Marin County Flood Control and Water
Conservation District
**Corte Madera Creek Flood Risk Management
Project, Phase 1**
Final Environmental Impact Report
Volume 1: Comments and Responses to Comments
State Clearinghouse No. 2020080353

**Marin County Flood Control and Water
Conservation District
Corte Madera Creek Flood Risk Management
Project, Phase 1
Final Environmental Impact Report
Volume 1: Comments and Responses to Comments
State Clearinghouse No. 2020080353**

Figure 2.6-1 Staging, Stockpile, and Temporary Work Areas

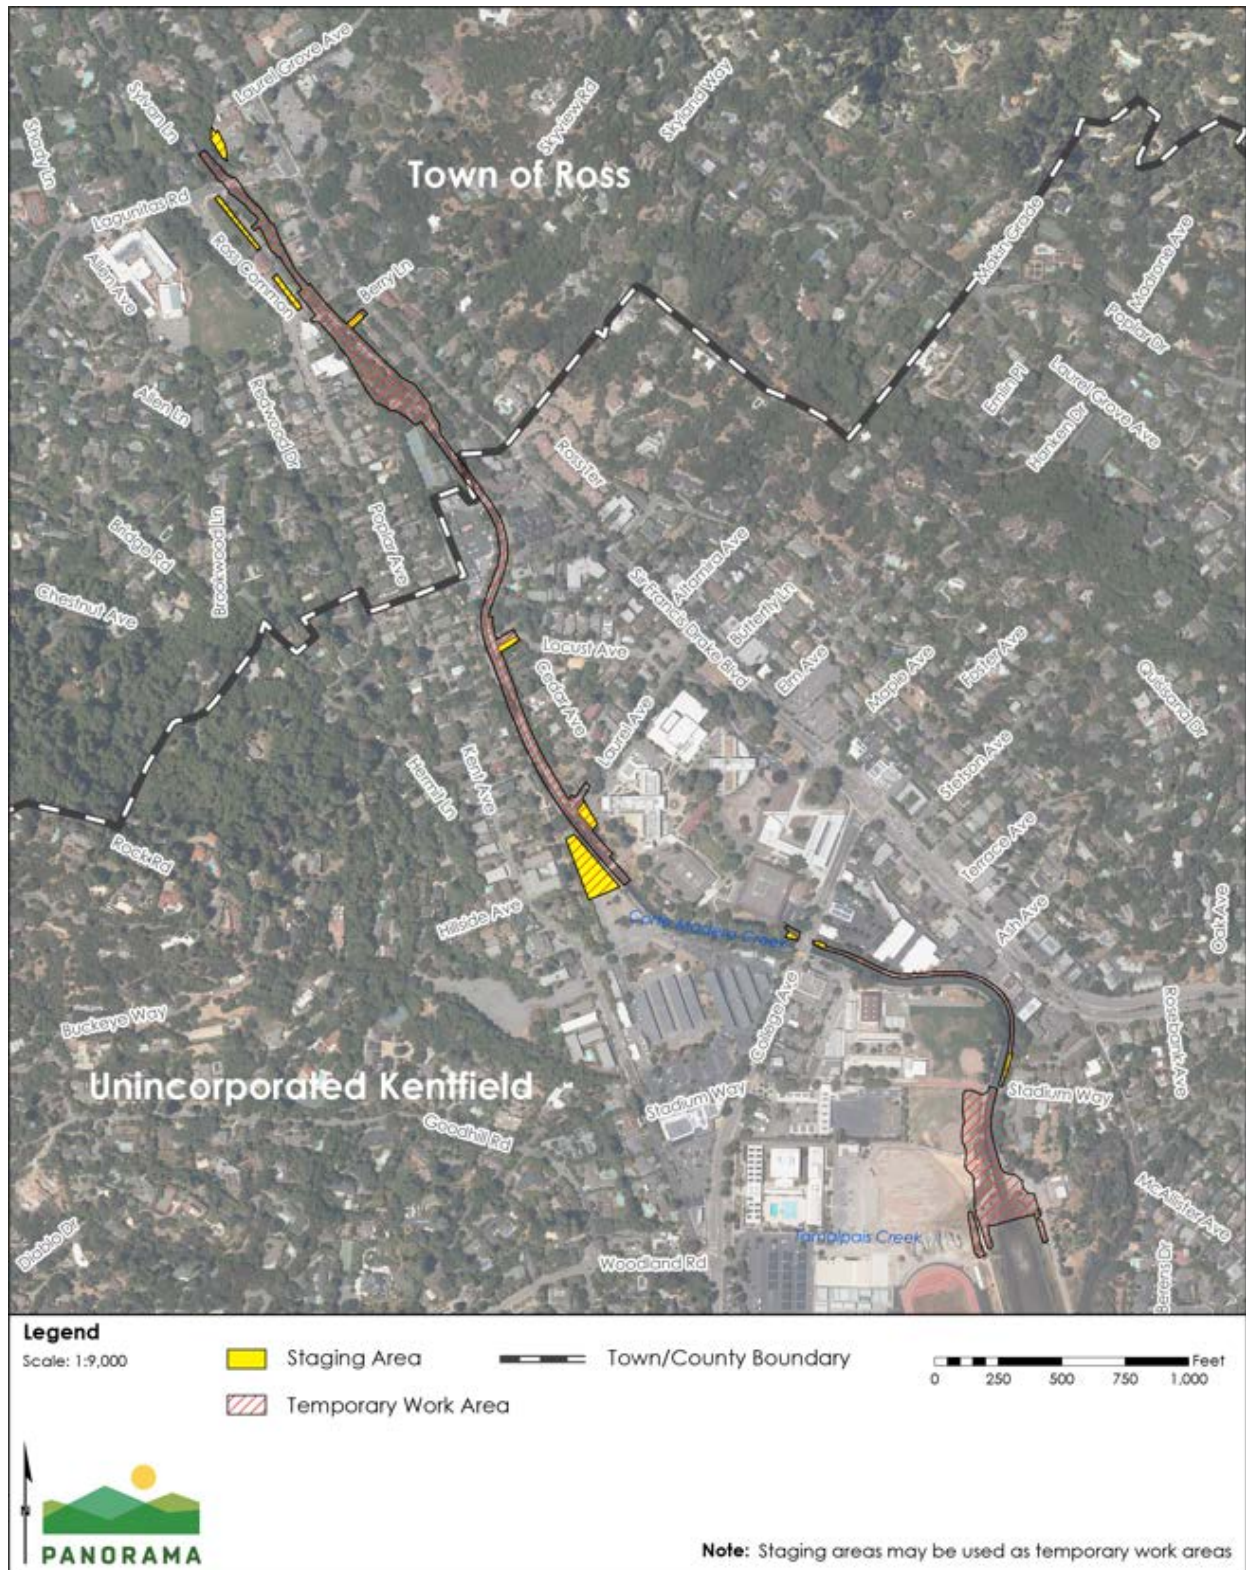
Figure 2.6-1; Figure 3.3-3; Figure 3.9-3 Remove staging area shown in COM project area. See Sheet C17 of 65% design plans for designated staging area.

The staging area located in Parking Lot 9 on college property **Figure 2.6-1** would take away from parking which is already in limited supply at the college and in Kentfield in general. Any use of college property would need to be returned to equal to or better than their current condition.

In response to comments B1-25 and B1-31, Figure 2.6-1 in the Draft EIR (page 2-27) has been revised, as shown on the following page.

Figure 3.2-2 Sensitive Receptors within 1,000 Feet of the Project Area

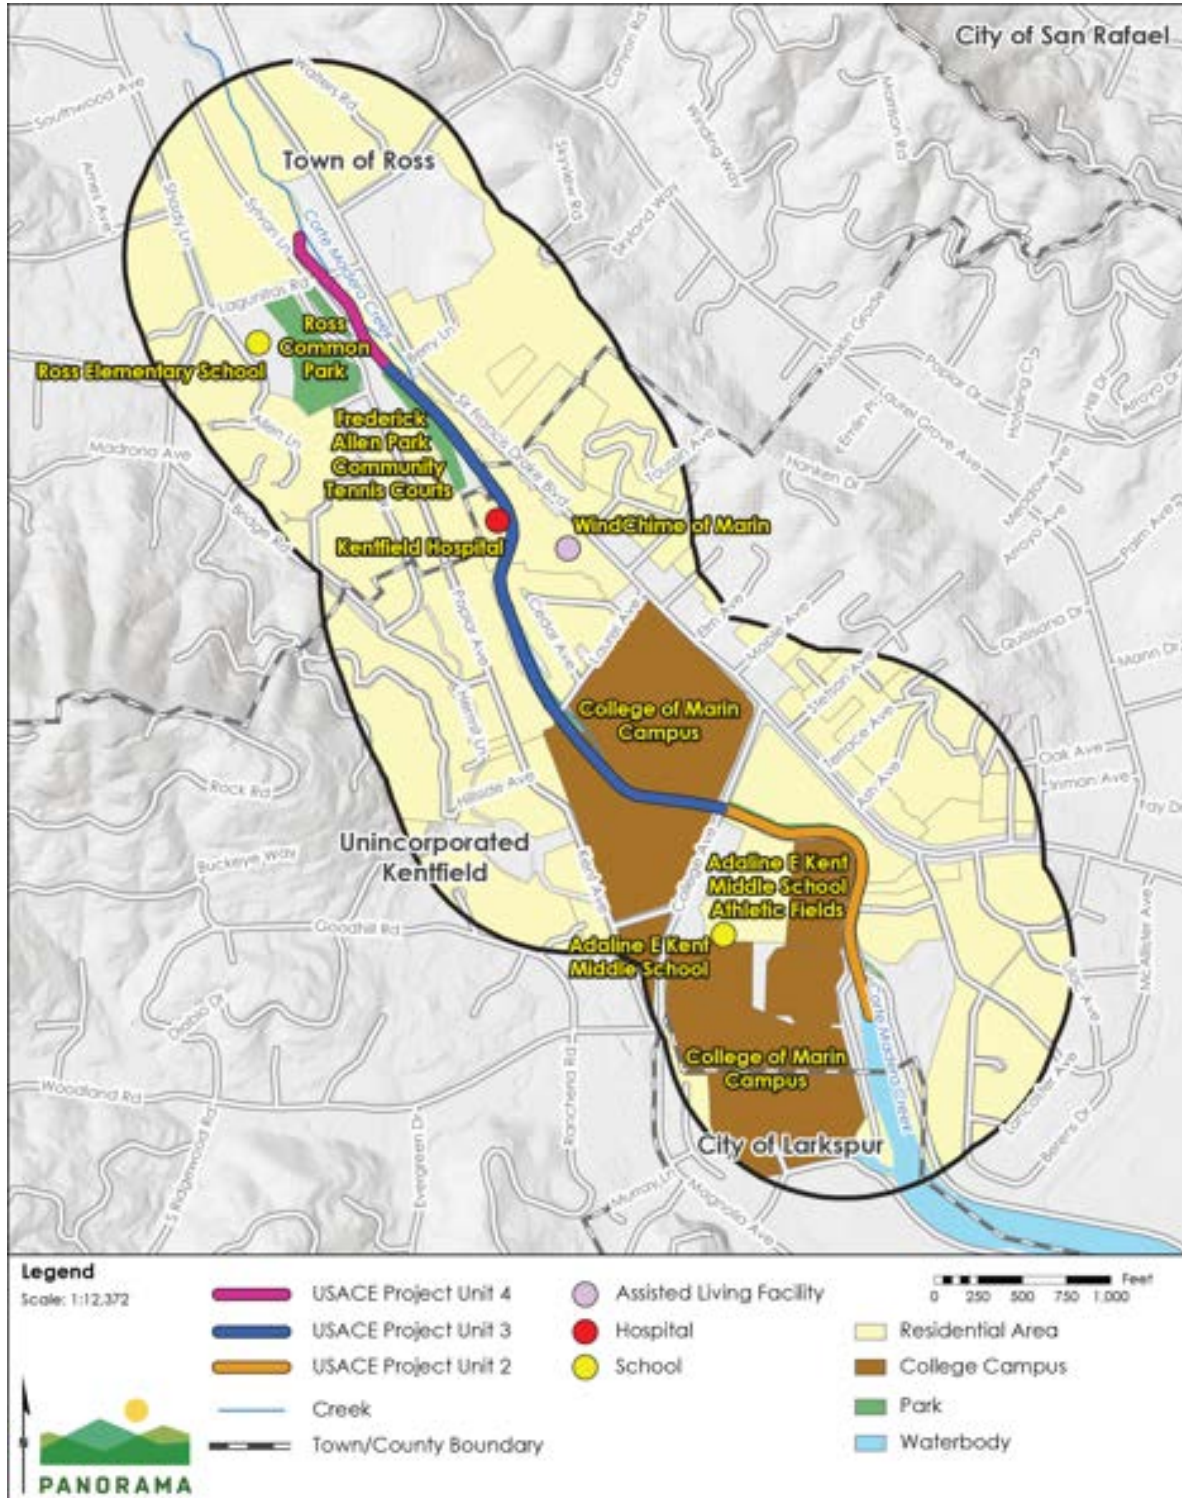
Figure 3.2-2; Figure 3.10-3 The site of COM's M&O Facility is mapped as Park (green). It should be mapped as College Campus (brown).

Figure 3.2-2 and Figure 3.10-3 have been updated as follows in the Draft EIR, to map the College of Marin's Maintenance and Operations Facility correctly as College Campus:

Figure 3.12-2 Parks and Recreational Facilities in the Project Area

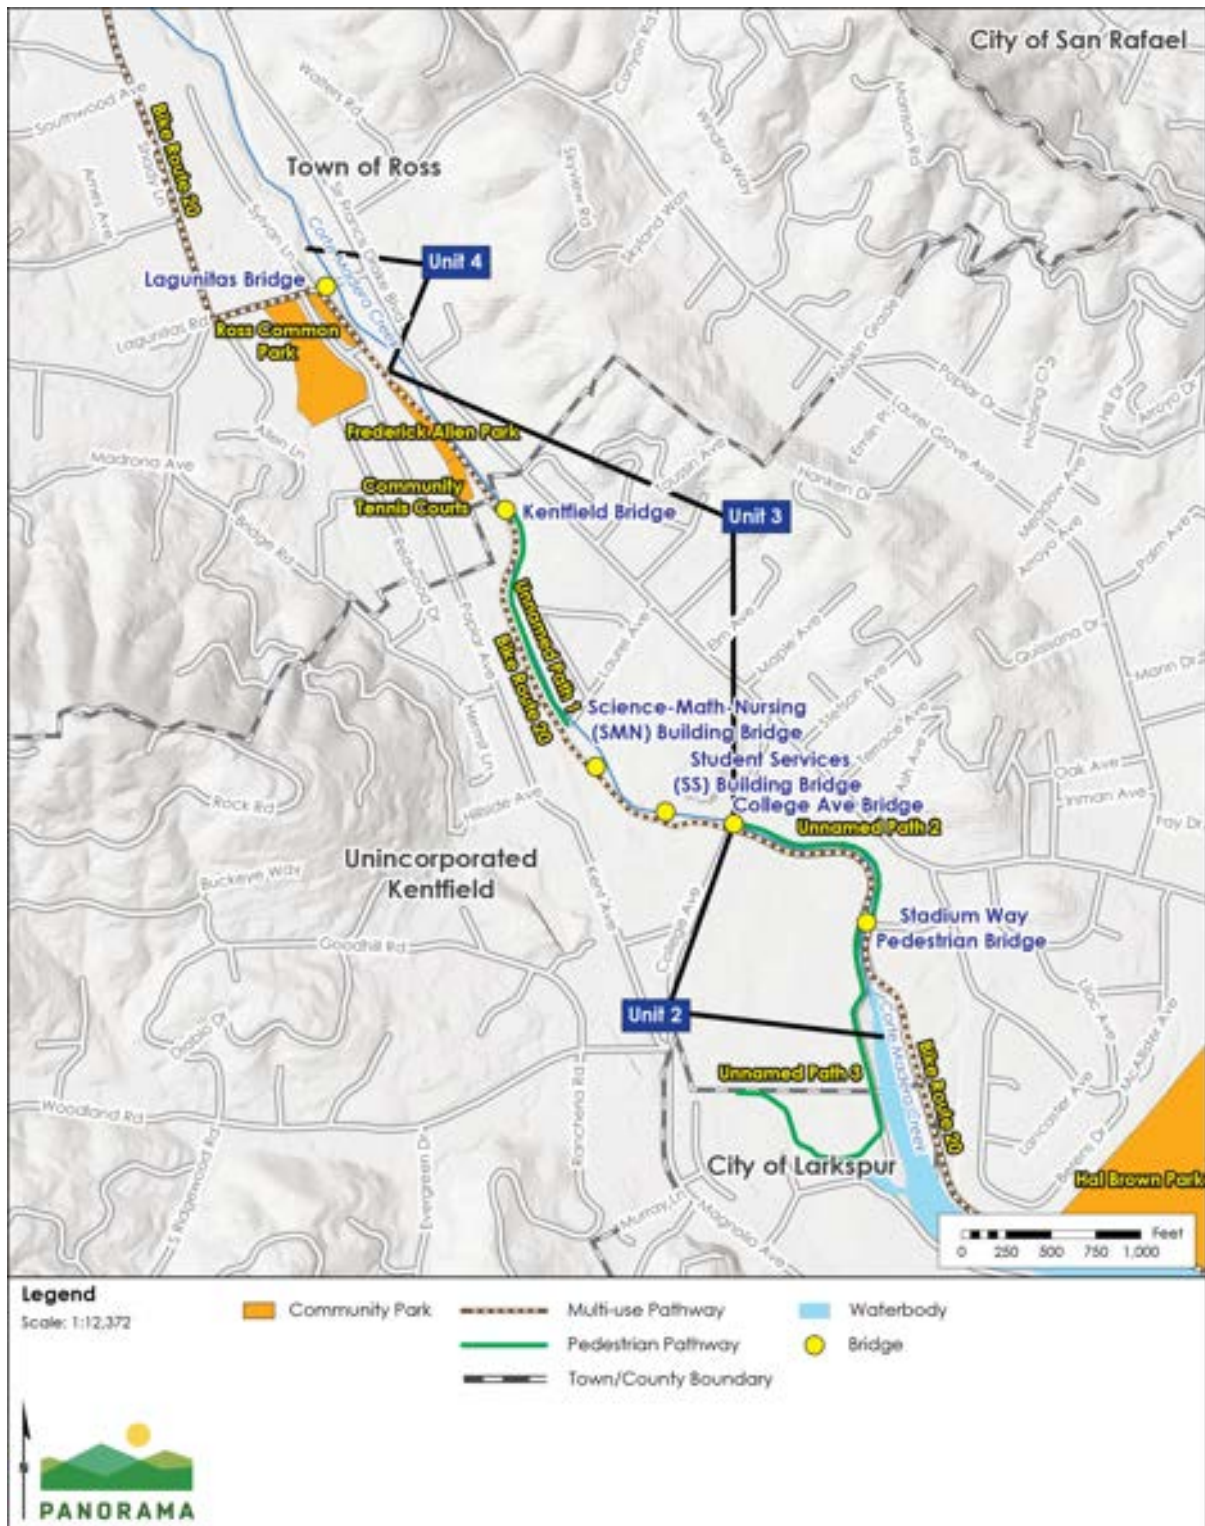
Figure 3.12-2 The COM M&O Facility is mapped as a campus recreation area. Remove that area from the map of recreational facilities.

Figure 3.12-2 has been revised in the Draft EIR as follows, removing the College of Marin Maintenance and Operations Facility.

Figure 3.13-1 Local Transportation Network

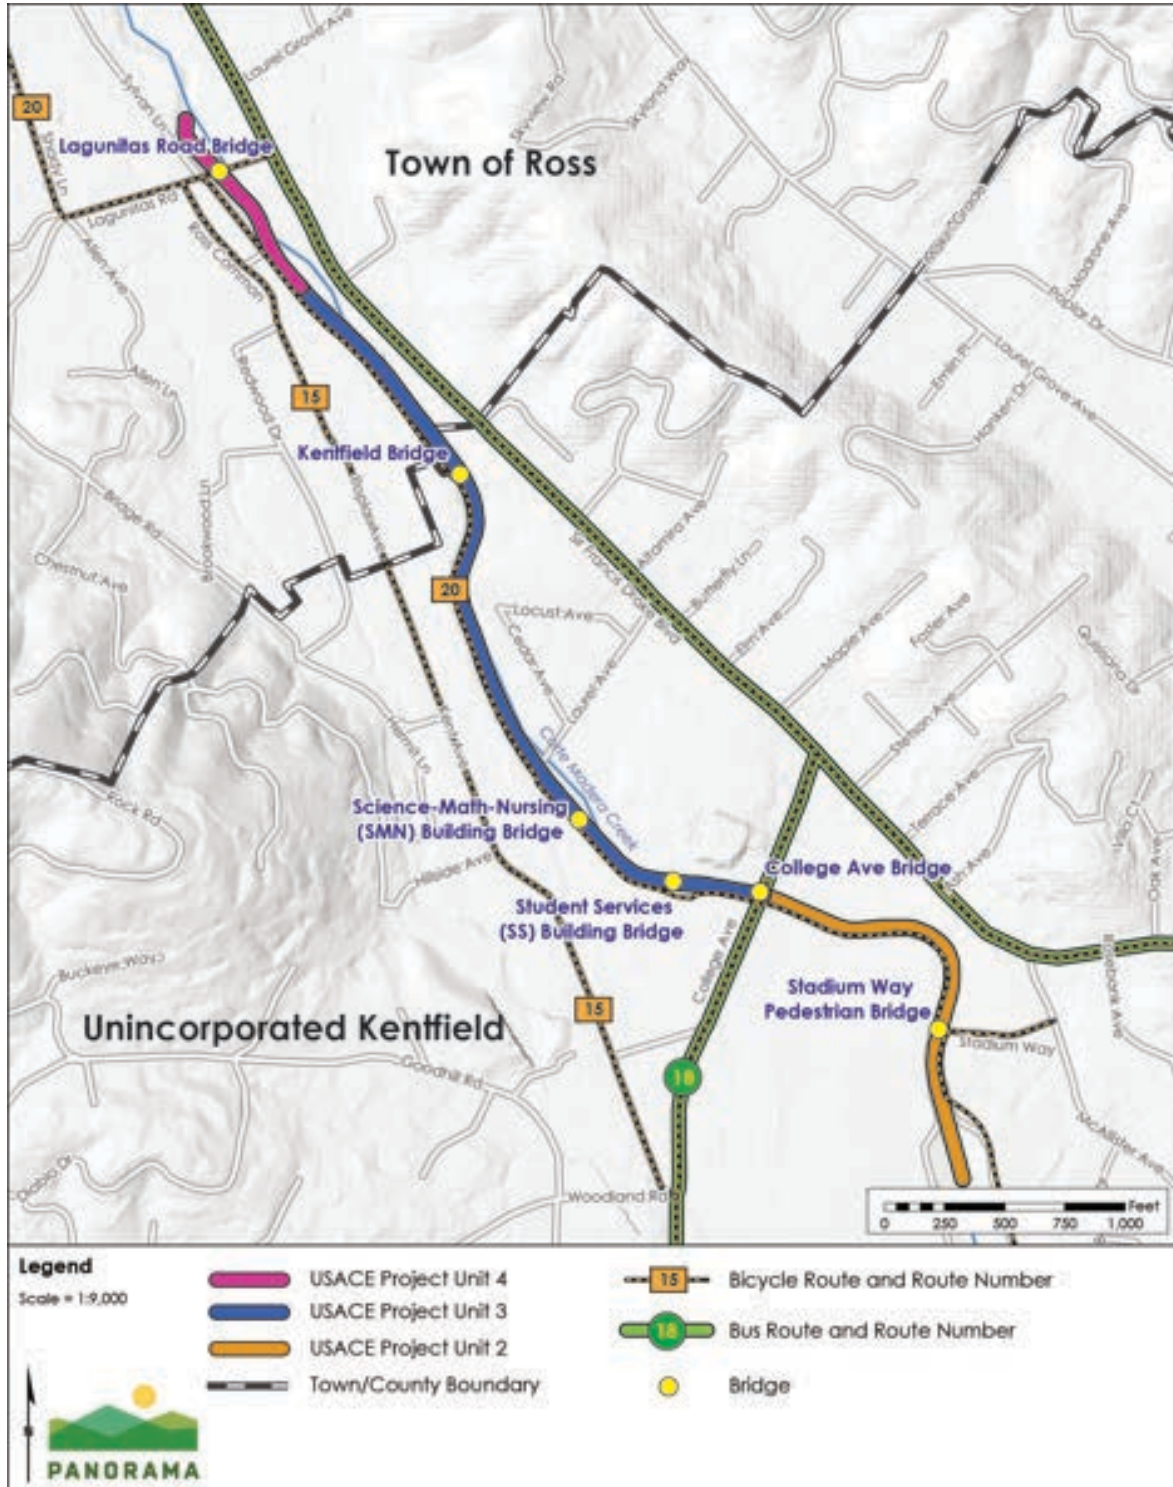
Figure 3-13-1 Unnamed Path #3 is mapped as a bicycle route. It is virtually never used by cyclists and the Marin County Bicycle Coalition does not consider it a bicycle route.

In response to comment B1-45, Figure 3.13-1 in the Draft EIR (page 3.13-3) has been revised as follows:
